MONTANA AREA OFFICE DECISION DOCUMENT
ST. MARY DIVERSION DAM
ST. MARY UNIT, MILK RIVER PROJECT

PURPOSE OF PAPER: Recommend a preferred structural alternative for continued analysis for the replacement of the St. Mary Diversion Dam and Headworks which considers minimizing public safety concerns, providing bull trout passage and entrainment protection, and concerns raised by the Milk River Project stakeholders.

Bull Trout Passage at the St. Mary Diversion Dam

A summary and response from the
St. Mary Bull Trout Biological Review Team

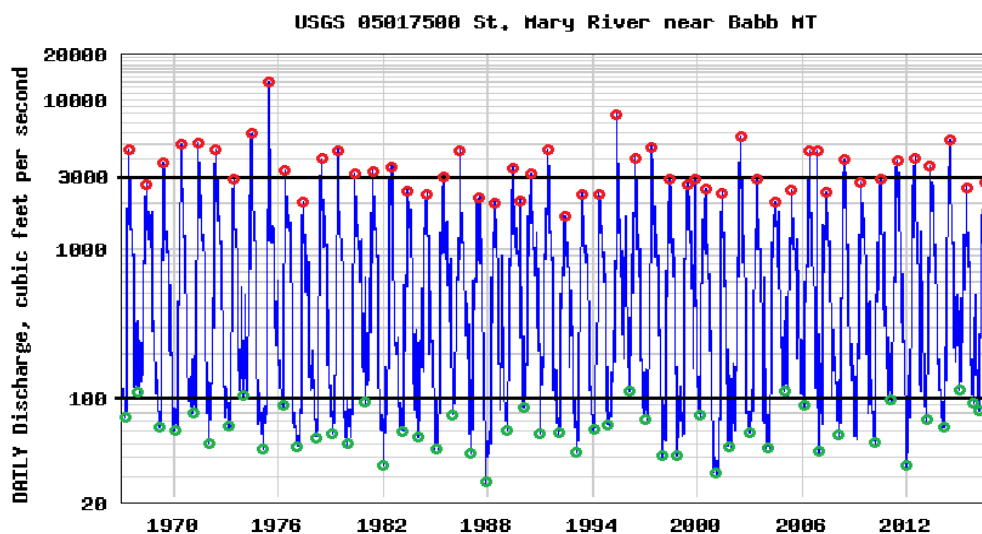
The BRT recommends that the Crest Notch be capable of capturing all available instream flow below a minimum of 100 cfs (i.e., the entirety of base flow; Figure 3), with the remainder of the Crest and Rock Ramp designed to withstand and safely pass remaining flows with minimal structural damage.

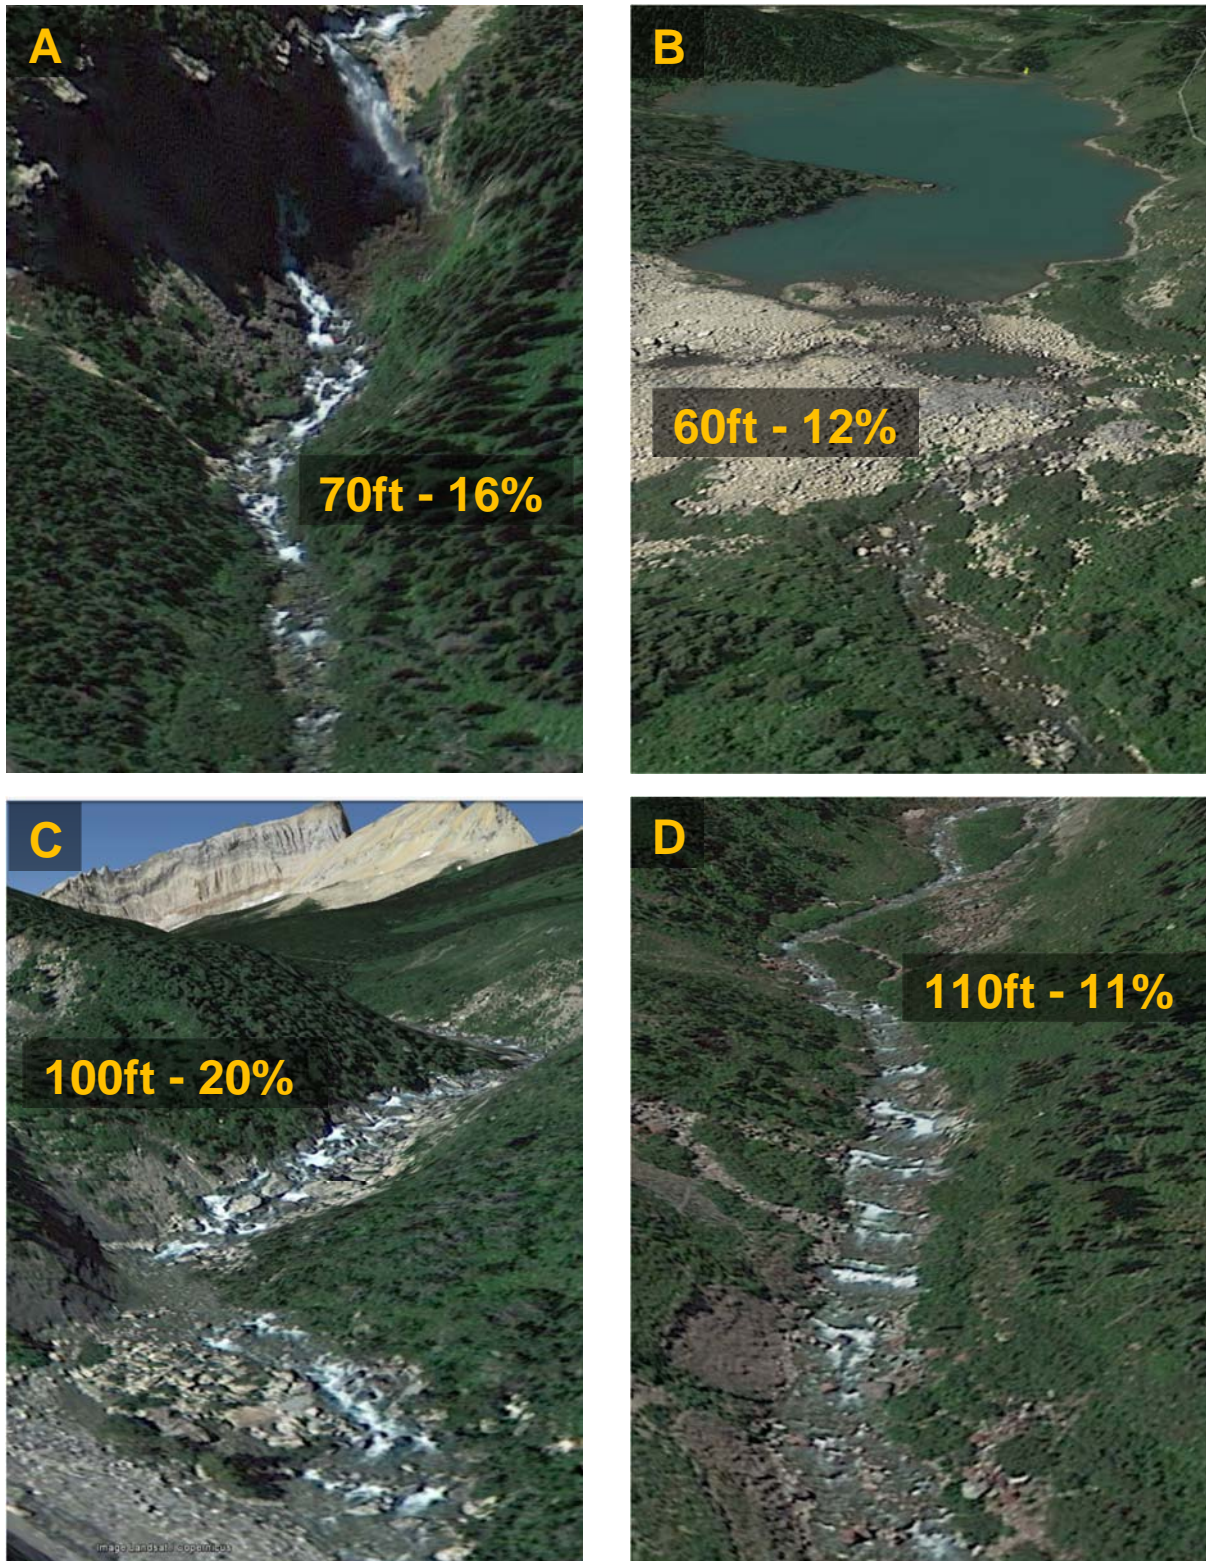
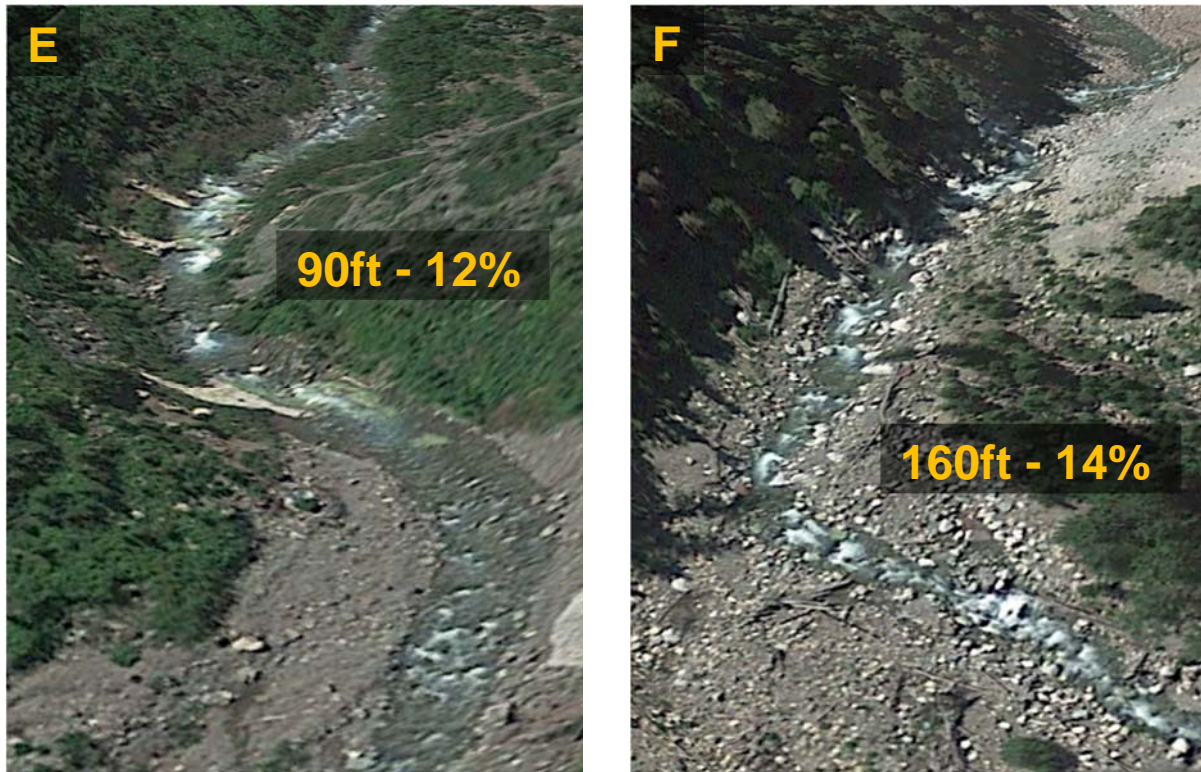
As discussed earlier, the TSC-modelled Rock Ramp has a gradient of 10% over the resultant 60 feet of total ramp length. Other than the previously mentioned swimming performance estimates that relate more to stream velocities than gradient and the general NMFS (2008) recommendations in Table 2, the BRT cannot find data-driven scientific support for passing Bull Trout over a consistent 10% incline of any length. Although resultant water velocities on the modelled ramp appear to be manageable at most flows, a 10% gradient seems excessive when compared to natural stream gradients encountered by Bull Trout during migrations from the lower river to the spawning area in upper Boulder Creek. Average stream gradients along this corridor vary from 0.2% in the relatively flat 1-mile stretch of river from the Diversion upstream to the mouth of Swiftcurrent Creek to 2.9% over the lower 4 miles of Boulder Creek (Table 3). Further, with the exception of the Diversion Dam itself, nowhere along the entire 20.1-mile corridor do fish encounter waterfalls, cascades or other vertical passage impediments with gradients greater than 4.0%. In other St. Mary drainages, however, Bull Trout regularly negotiate similar and even higher gradient impediments during annual spawning migrations (Figure 4). All of these obstacles, however, possess high channel complexity that provides passage through natural step-pool sequences formed by bedrock sills, large boulders, logs and/or debris – habitat features not currently incorporated in the design for the entire Rock Ramp surface.

The problem with excessive gradient is really the associated water velocities that impede upstream movement of fish, especially during high flows. However, simply reducing ramp gradient to accommodate the swimming capabilities of fish comes at the expense of a proportional increase in the total distance that fish must travel to ascend the ramp. Ultimately, if water velocities exceed the sustained swimming abilities of the target species for extended distances, adequate resting habitat must be provided or fallback will be an issue. Of course adding roughness and complexity will break up laminar flow and reduce local velocities but they too come at a price – increased cost and maintenance. The real challenge here is finding that unique combination of gradient, velocity, length and roughness that works best for fish moving upstream on the ramp surface during higher flows. The BRT would like to see resultant surface velocities from additional ramp modeling that includes reduced ramp gradients of 5-7%.
